## Memo

### Development Assessment

**Subject:** DA2024/1827 11 Loch Street, Freshwater.

#### 1. Southern Side Boundary

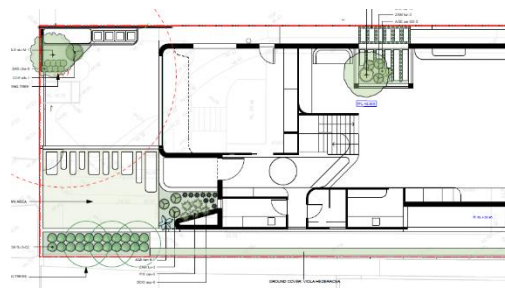
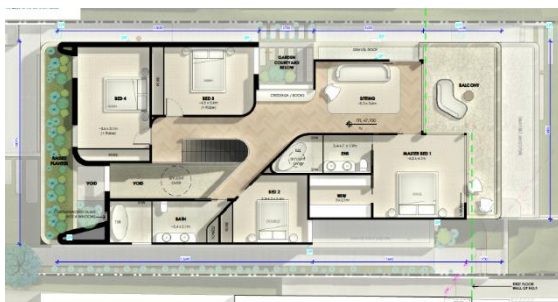
At the panels request, vegetation planting was requested to be considered for the southern side boundary setback to soften the expanse of hard landscaping present.

Plans submitted by the applicant (registered in Council's system 29<sup>th</sup> May 2025) have addressed this matter by introducing some soft landscaping. The narrow planter balances the request for softening with the need to manage stormwater and keep moist areas away from the edge of the main footings in an area that receives limited sunlight penetration.

As such, it is recommended to include the following amended plans in the approved plans condition to show the added landscaped area (see '*Recommendation*').

- Landscape Plan Upper Ground LPL\_1401 Rev D dated 29/05/2025
- Landscape Plan First Floor LPL\_1402 Rev D dated 29/05/2025
- First Floor Plan A102 Rev dated 29/05/2025

## 2. Screen Planting around the pool

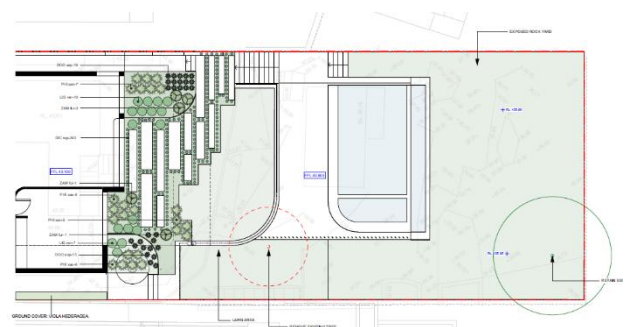
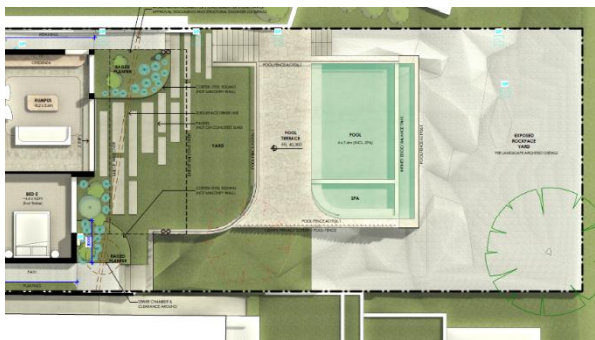
At the panels request, clarification is requested on landscaping surrounding the pool edge. To date, the architectural plans and the landscape plans indicated a different planting outcome for the outside of the pool (one with planting and the other without). The applicant has provided clarification by way of amended plans (registered in Council's System 29<sup>th</sup> May 2025) on the planting proposed on the outside of the pool.

Areas of exposed sandstone are evident at the rear of the property, and these are kept as a preference in the landscaping plans. This responds to the requirement of clause E6 of the Warringah DCP "*Retaining unique environmental features*". The alternative would be to fill the area to provide enough soil depth for landscaping with shrubs and trees. In addition, submissions received outlined concerns about vegetation blocking views across the rear of the adjacent lots.

As such, it is recommended to include the following amended plans in the approved plans condition to ensure consistency between architectural and landscape plans (see '*Recommendation*').

- Landscape Plan Lower Ground LPL\_1403 Rev D dated 29/05/2025
- Lower Ground Floor Plan A100 Rev - dated 29/05/2025
